Council Communication

Downtown Beautification Project Update

PIONEER AT LITHIA
 ASHLAND, OREGON

TREE REMOVAL AND DEMOLITION PLAN

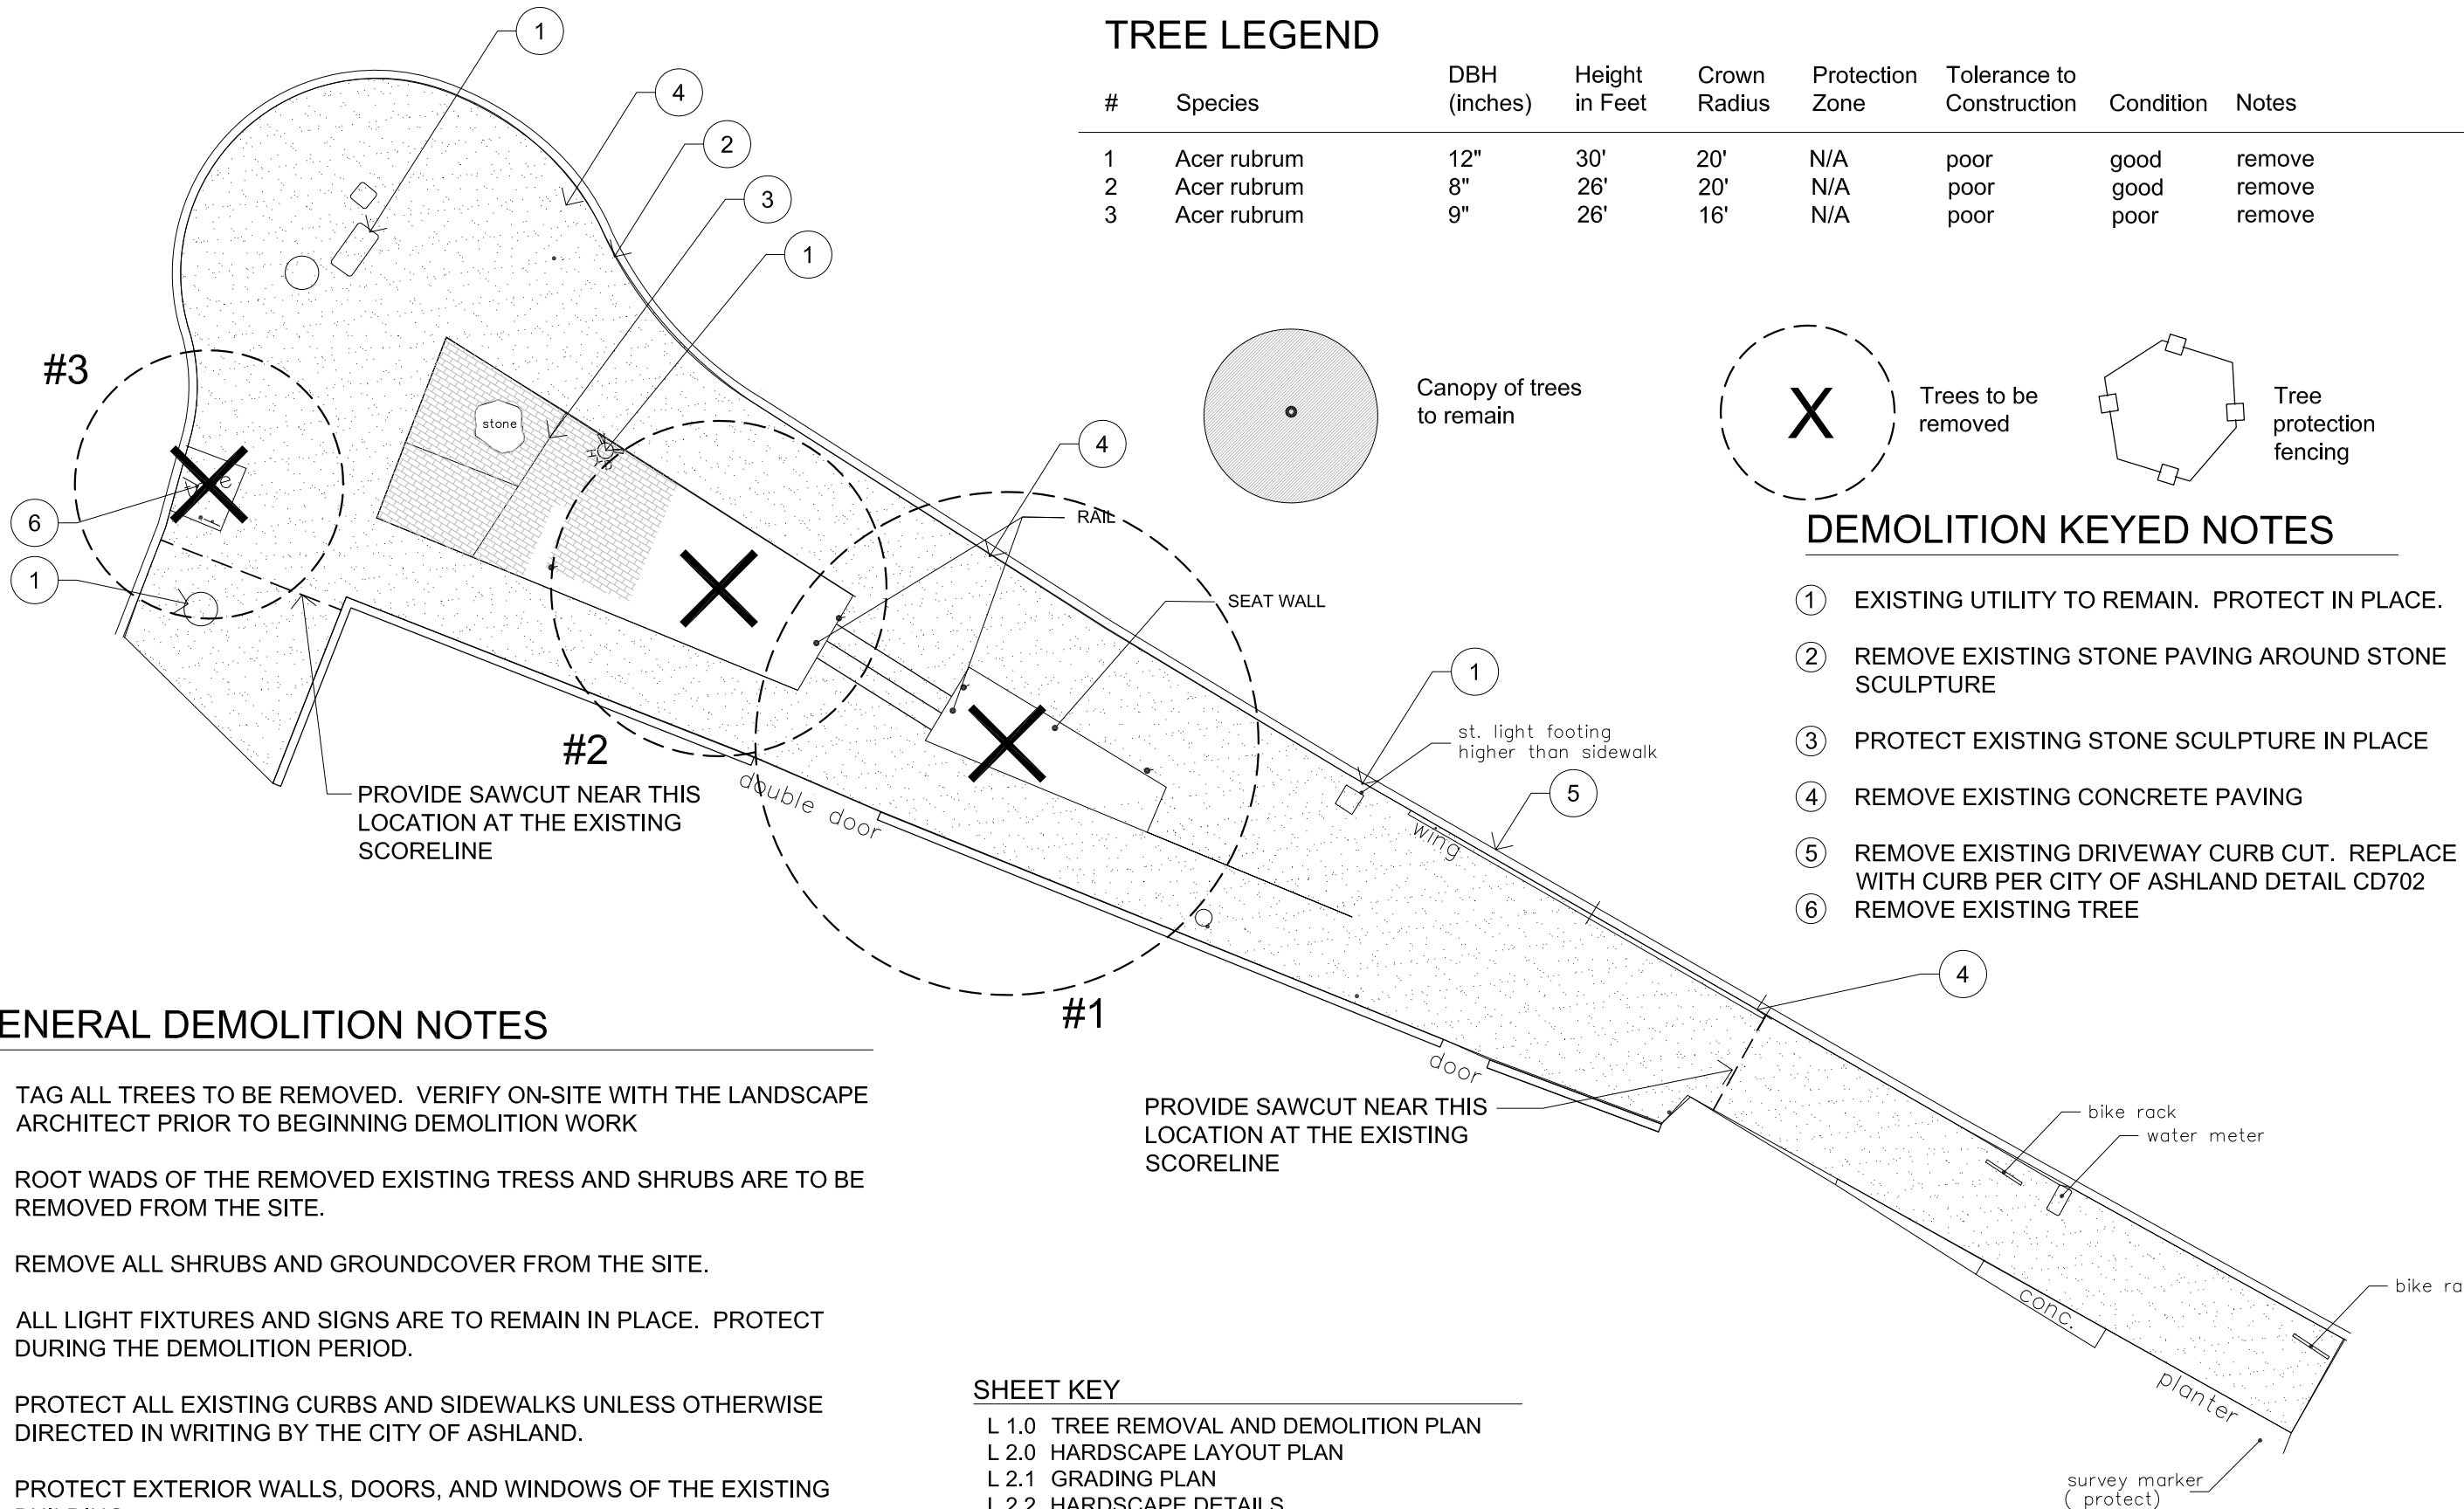
1. PER THE TREE INVENTORY, KENCairn STATES THAT THE EXISTING RED MAPLES HAVE POOR TOLERANCE TO CONSTRUCTION AND THAT THE WESTERLY MOST MAPLE IS IN POOR HEALTH. WITH THIS INFORMATION AND REVIEW OF THE PROPOSED DESIGN, I AGREE THAT ALL 3 MAPLES SHOULD BE REMOVED AND REPLACED PER PROPOSED PLAN.
2. THE EXISTING GRADE CHANGES IN THIS AREA AND THE GOALS OF THE REDESIGN, MAKE THE PROPOSED WALLS IMPORTANT TO THE FUTURE OVERALL USE OF THIS SPACE. REMOVAL OF THE MAPLES TO ALLOW FOR THE CONSTRUCTION OF THESE WALLS AND REQUIRED EXCAVATION AND FOOTINGS APPEARS TO BE MANDATORY DUE TO THE PROXIMITY OF THE TREES TO THE CONSTRUCTION.
3. WARRENS RED MAPLES AS REPLACEMENT TREES WILL PROVIDE QUICK GROWTH AND ARE READILY AVAILABLE IN LARGE SIZES, UP TO 4" CALIPER FROM NORTHWEST SHADE TREES.

#	Species	DBH (inches)	Height in Feet	Crown Radius	Protection Zone	Tolerance to Construction	Condition	Notes
1	Acer rubrum	12"	30'	20'	N/A	poor	good	remove
2	Acer rubrum	8"	26'	20'	N/A	poor	good	remove
3	Acer rubrum	9"	26'	16'	N/A	poor	poor	remove

ORIGINAL CORNER DESIGN

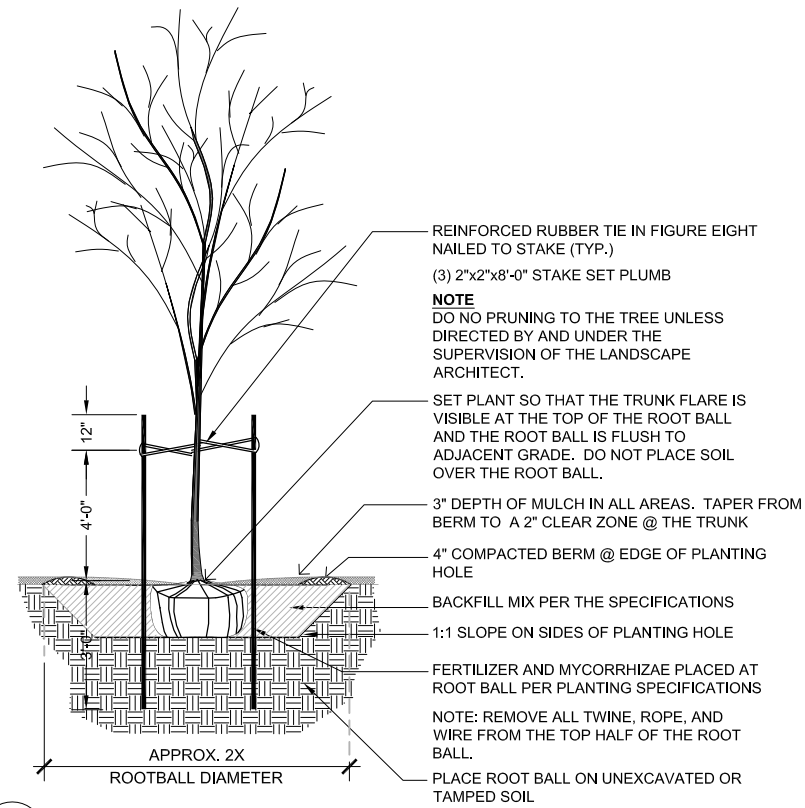
REPLACED EXISTING MAPLE THAT WAS ROOTBOUND W/ NEW TREE

REPLACED EXISTING MAPLE WITH NEW TREE

REMOVE EXISTING TREE DUE TO SITE WORK

PROVIDE STRUCTURAL SOIL THROUGHOUT THIS AREA

PROVIDE NEW TREE GRATE AND TREE IN PLACE OF EXISTING COMPARTMENTALIZED MAPLE

PERVIOUS PAVERS AROUND EXISTING PUBLIC ART DISPLAY

RETAIN EXISTING MAPLE AND SOIL GRADE AROUND TREE

REMOVE EXISTING TREE
RETAINING WALL / CURB

MAINTAIN EXISTING RAMP AND STAIRS PER PREVIOUS DESIGN

NOTE:
WALL FOOTINGS TO BE LOCATED UNDER PROPOSED PAVED AREAS

- The arborist’s assessment of the existing red maple tree east of the proposed steps (*Tree #1*) notes the tree as being “in a very restricted root zone and has likely reached its potential growth” and in “moderate health”. Currently the tree’s roots are beginning to impact the public sidewalk (sidewalk cracks and lifting) just east of the tree. This is viewed as a hazard to pedestrians and should be corrected by removal and replacement of the public and private sidewalks in that vicinity to provide a safe pedestrian zone. Based on our professional experience, the necessary construction in that area will have a negative impact to the tree that will ultimately expedite the tree’s decline. The alternate design reflects the original design with this tree being removed.

- The arborist’s assessment of Tree #2 (Red Maple tree) along Lithia Way notes the tree as being in good health although it points out that the soil appears compacted and devoid of organic materials. In its current state, the finish grade of the planter around the tree is elevated +/-6” above the adjacent public sidewalk. Per the original design, the tree was removed and the planting area lowered to the sidewalk grade. The alternate design retains the existing red maple (*Tree #2*) and the grade of the planter around the tree. We propose that an application of mycorrhizal inoculant be added to the soil. The existing modular block wall/curb adjacent to the sidewalk is removed and replaced with a poured in place concrete curb to retain the grade.

The area of the planter will be slightly decreased from the west to allow for a low seatwall to be installed near the public art display. The proposed steps and ramp adjacent to the building will be retained by a 6" wide poured in place concrete wall. To reduce the impacts to the tree's roots, the wall's footing will be designed so that any spread portion of the footing will be located underneath the paved areas.

- The area around the public art display will remain in permeable pavers although will be slightly smaller than the original design. In order to reduce impacts to the existing planter, the seatwall from the original design was relocated closer to the existing edge of the planter (to the west) and thus the reduction in the area of permeable pavers.

- The arborist's assessment of the existing red maple tree adjacent to Pioneer Street (*Tree #3*) notes the tree as being "in a severely restricted root zone" and being in "moderate health". Currently the root flare is growing out of the cutout for the tree. Based on our professional experience, we believe this tree has not only reached its maximum potential but is also in decline based on the condition bark on the west side. The alternate design reflects the original design with the removal of this tree. However, KLA is proposing the addition of a tree grate and frame along with the use of structural soils at this location. We believe that the addition of the structural soil will not only aid this new tree in reaching its urban potential but will also allow for the existing tree to remain (*Tree #2*) to increase its rooting area.

- The tree that was selected for the replacement of *Tree #3* is an *Quercus frainetto* 'Schmidt' (Forest Green Oak). This tree has been proven to do well in urban conditions (limited moisture, reflected heat, and compacted soils). With the use of structural soils under the replaced paved areas and the introduction of irrigation at the tree well this tree should develop into a nice sized street tree.
